Transport Statement

**Proposed Residential Development
Stansty Fields, Gwersyllt**

Prepared for Castle Green Homes

Doc Ref: LB/220743/TS/6

Drawing No.	SCP/220743/ATR02
Rev.	F

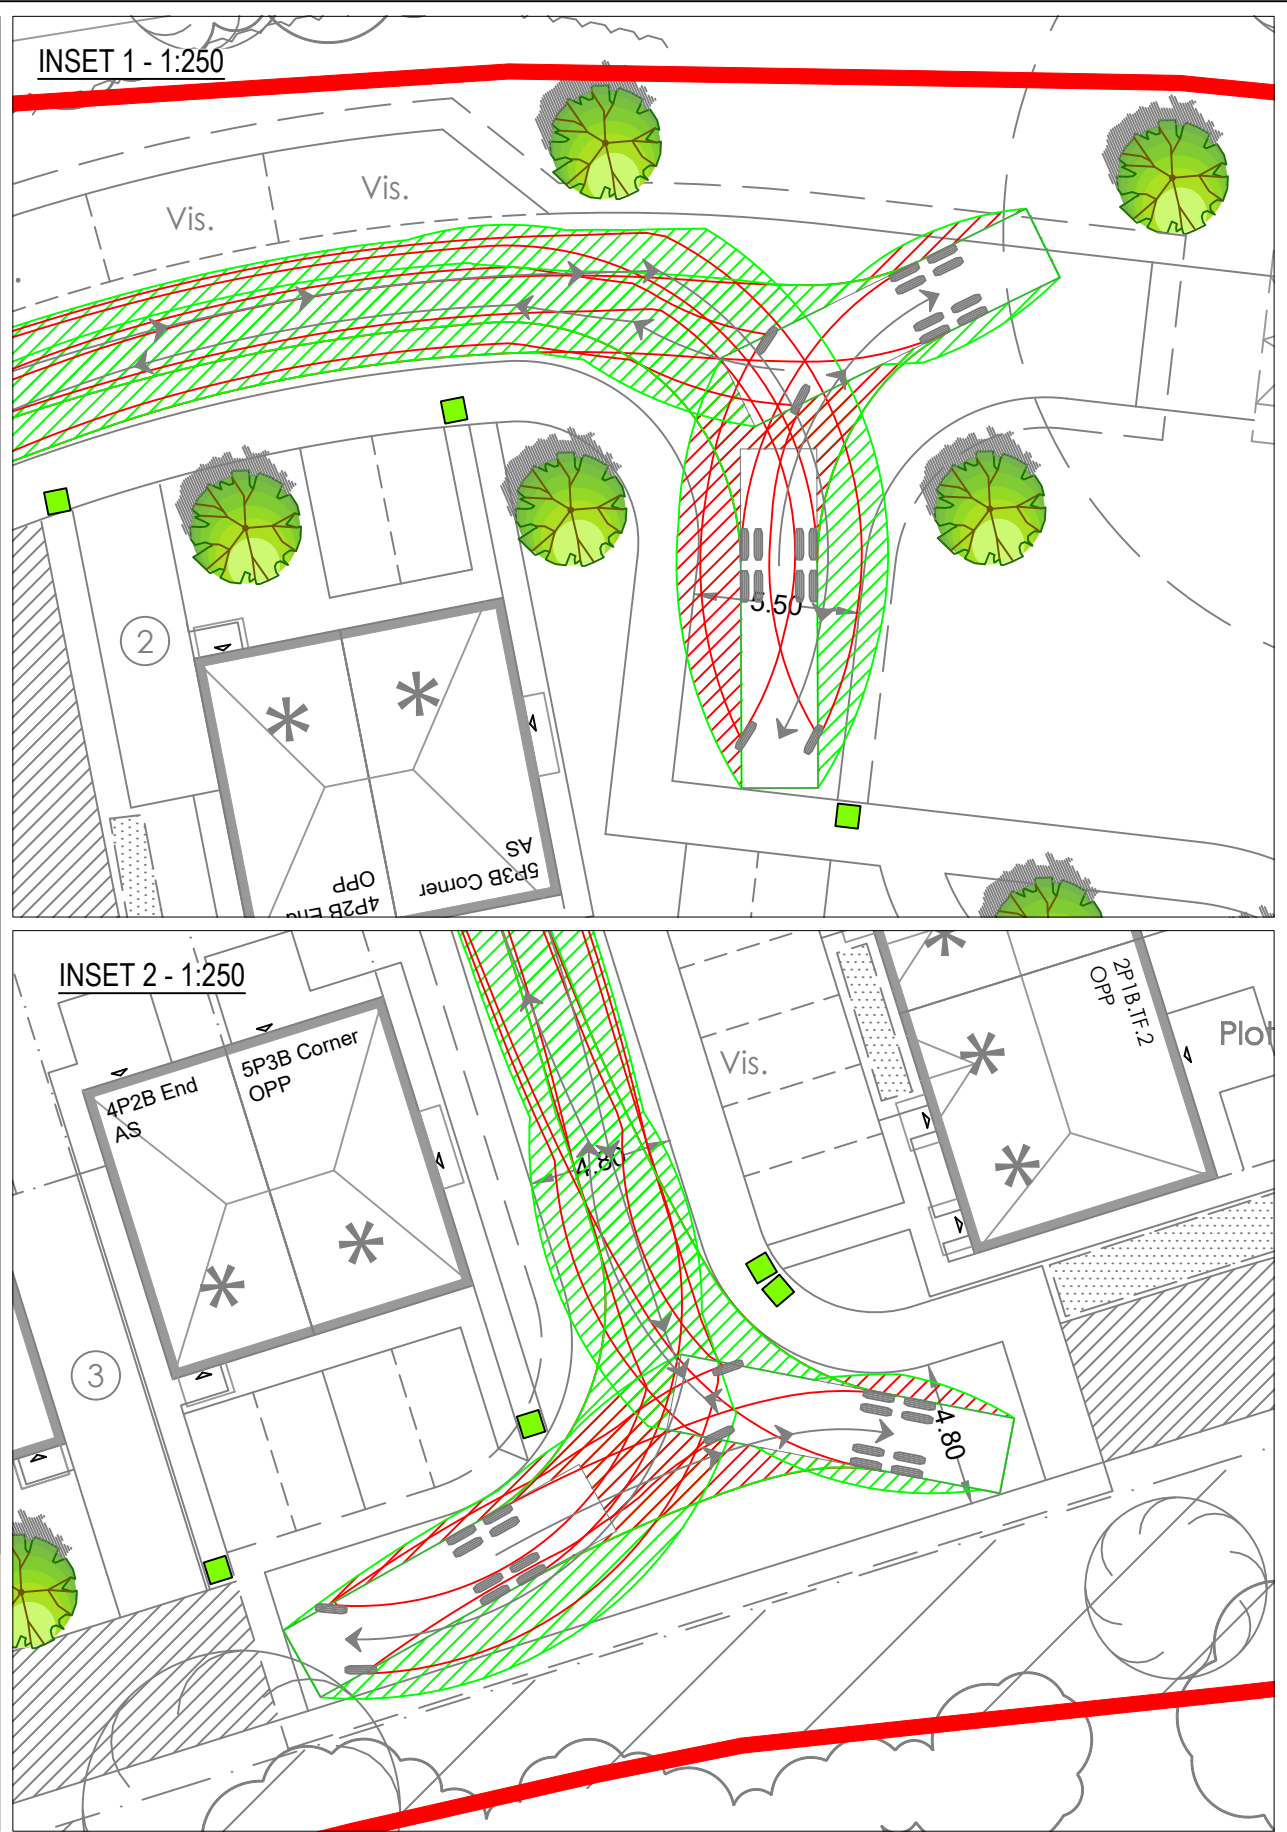
The swept path assessments provided in the TS clearly show the RCV over-running the footway in places. **This is unacceptable from a road safety perspective and is not considered safe.** The dimensions of the turning head and bends should be amended to ensure a refuse vehicle can turn without overrunning the footway.

- **Internal Site Layout**
 - Provide a dimensioned drawing of the internal road layout, including road widths and turning heads.
 - Amend turning head dimensions to ensure refuse vehicles can turn without overrunning footways.

Project Title:	
MOLD ROAD, GWERSYLLT, WREXHAM	
Drawing Title:	
PROPOSED FOOTWAY LINK TO NEAREST BUS STOP	
Drawing No.	Rev.
SCP/220743/SK03	G

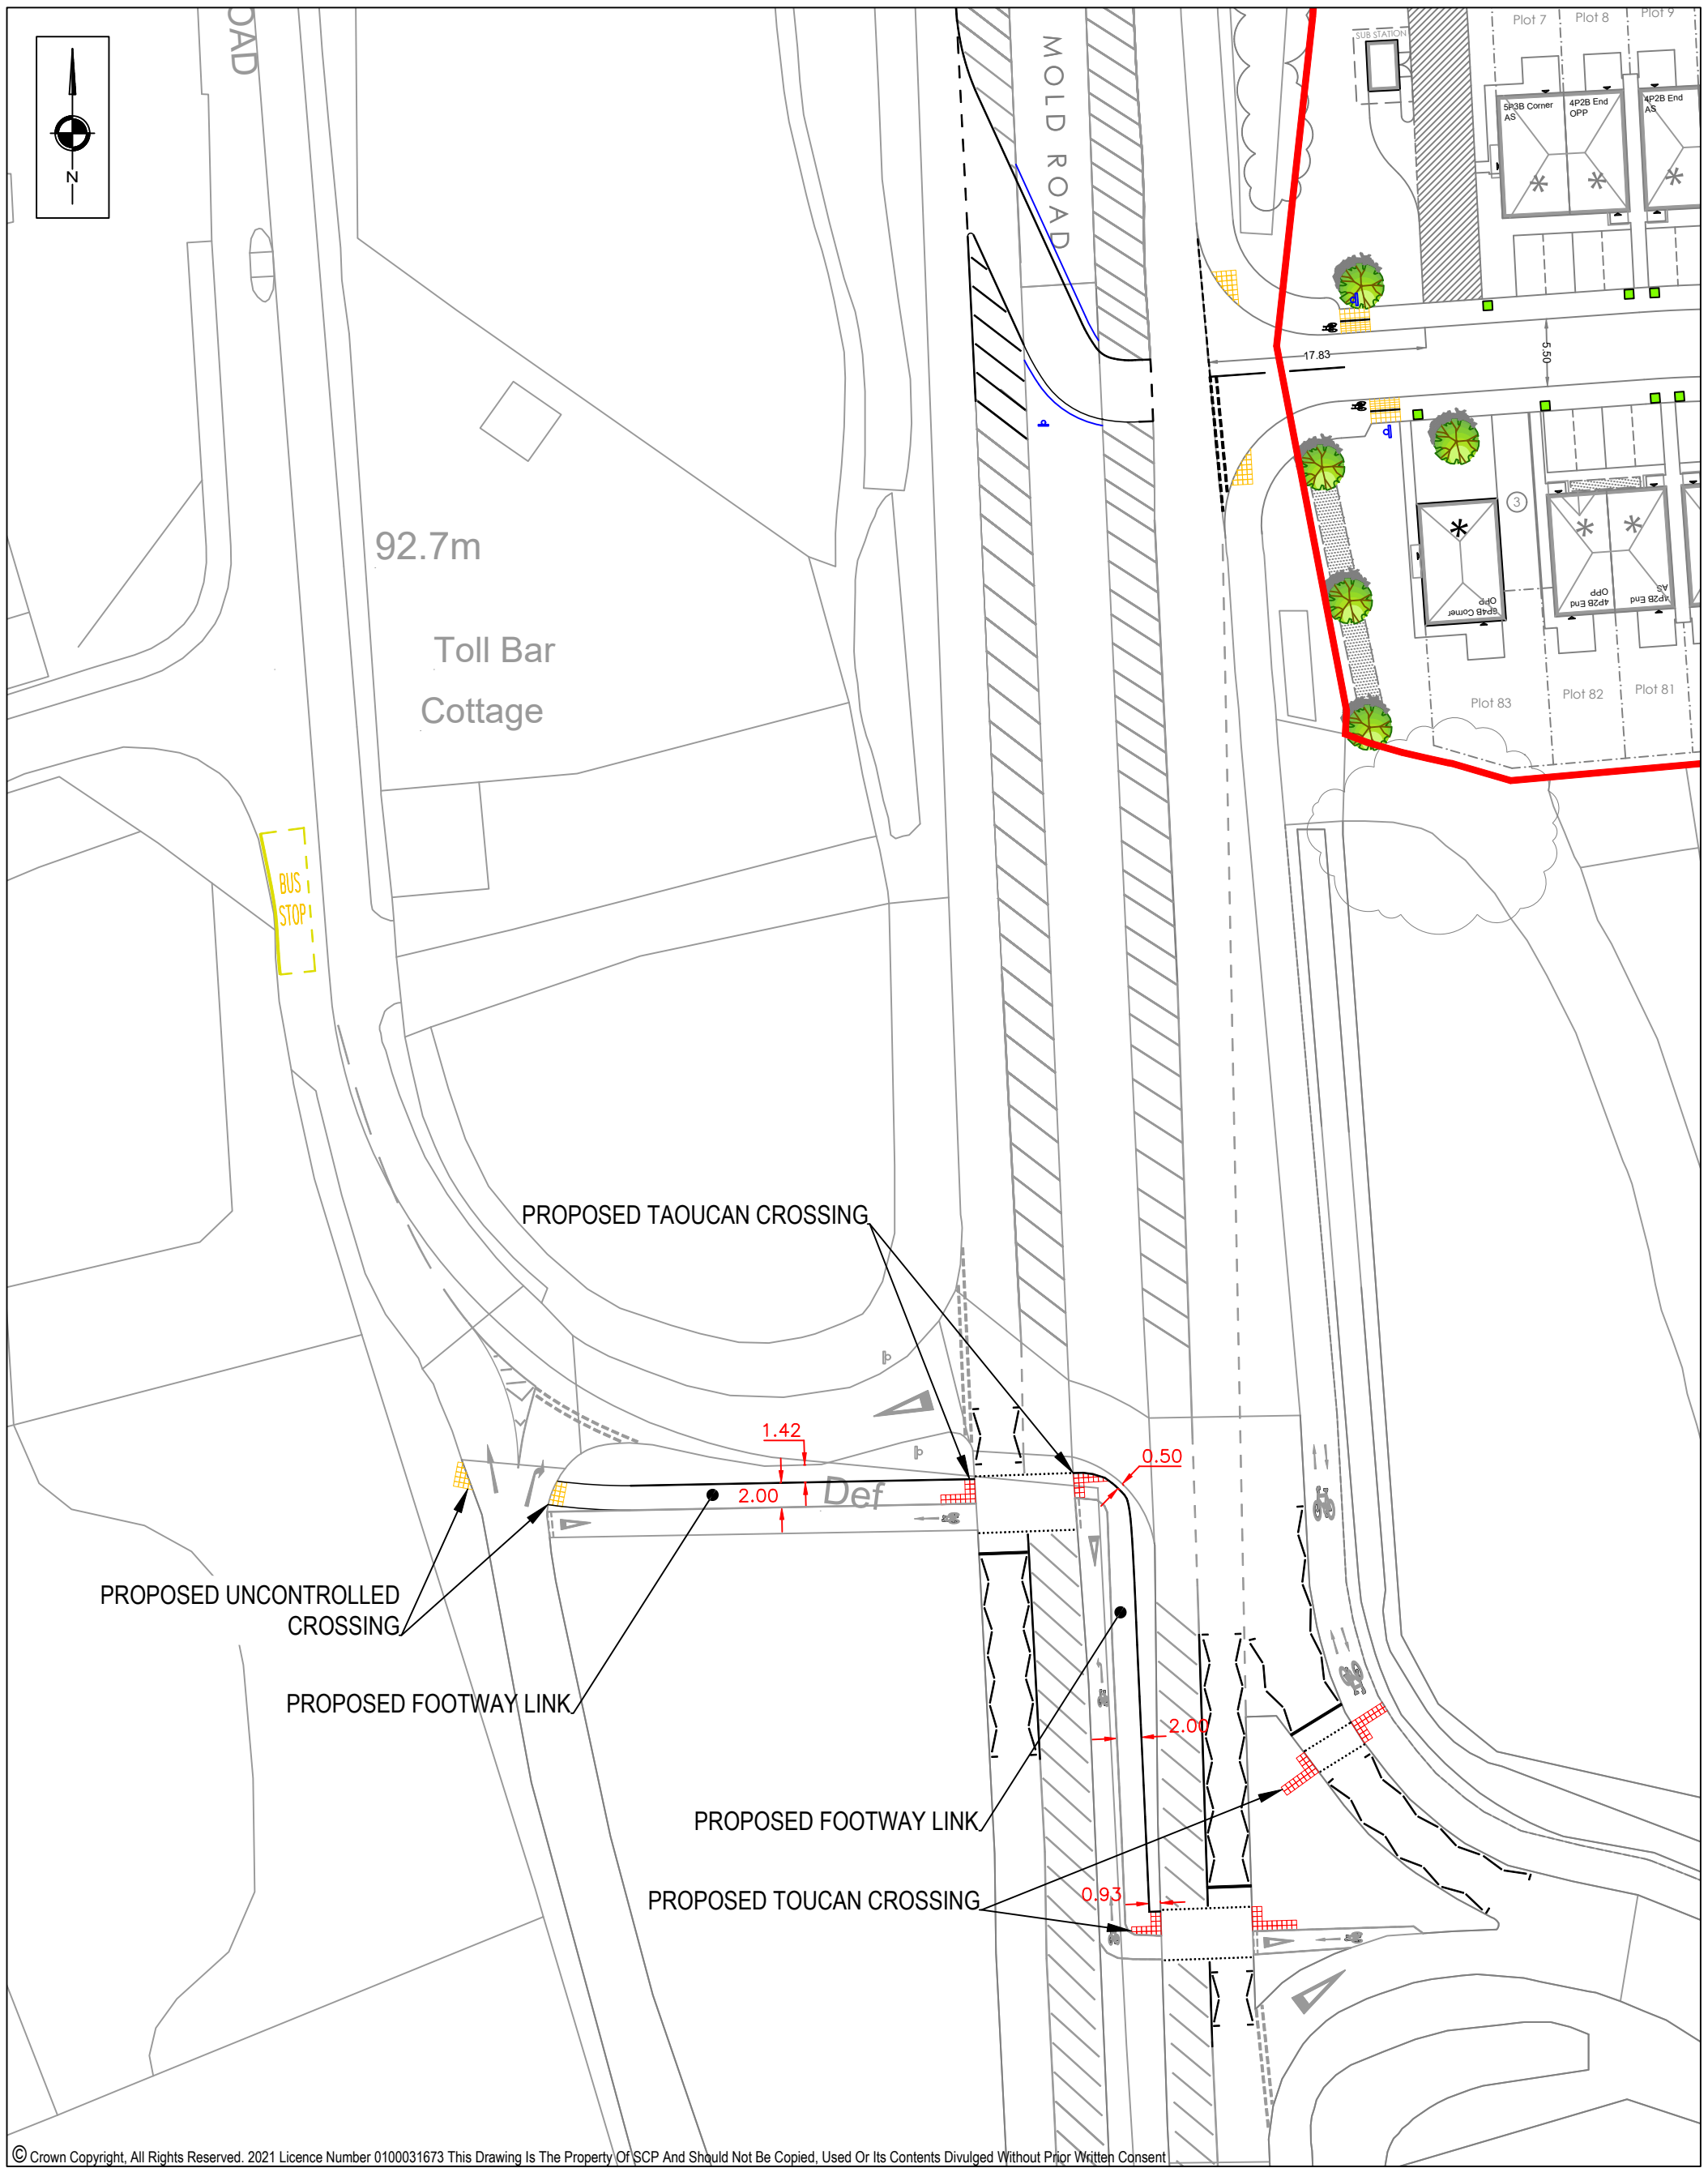
PROBLEM		1-1
Location:	Issues with proposed pedestrian footway.	
Summary:	Obstructed footways and lack of uncontrolled crossings that meet the required DfT standards will increase the risk of injuries to non-motorised users.	
It is proposed to provide a footway between Old Mold Road and Stansty Chain Road following the route of the existing cycle facilities. Two issues have been identified: 1. There is a sign, signposts, lamp column and bollard located within the new footway (photos). 2. There is no tactile paving associated with the existing crossing over Old Mold Road (photo)

PROBLEM		1-2
Location:	Central reservation Mold Road	
Summary:	A lack of clear separation between the new footway and carriageway will increase the risk of vehicles striking pedestrians on the new footway increasing the risk of injury.	
It is proposed to provide a footway between Old Mold Road and Stansty Chain Road following the route of the existing cycle facilities. Where the footway crosses the central reservation, it is noted that the footway will be very close to the right turn (central reservation crossing) for vehicles exiting Old Mold Road. A lack of clear separation between the new footway and carriageway will increase the risk of vehicles striking pedestrians on the new footway increasing the risk of injury.		
RECOMMENDATION		
It is recommended that as a minimum at least 500mm is provided between the edge of the footway and the carriageway to create an area of separation.

Problem No. in RSA Report	Problem Accepted (Yes/No)	Recommended Measure Accepted (Yes/No)	Alternative Measure / Design Team Response
1.1	Yes	Yes	To be addressed at detailed design stage.
1.2	Yes	Yes	Drawing number SCP/220743/SK03 has been updated (Rev A) as recommended to provide a minimum 0.5m separation between the edge of the footway and carriageway.
1.3	Yes	Yes	Drawing number SCP/220743/SK01 has been updated (Rev A) as recommended to provide a dropped kerb crossing with tactile paving across the access, the design of which can be agreed at the detailed design stage.
1.4	Yes	Yes	To be addressed at detailed design stage.
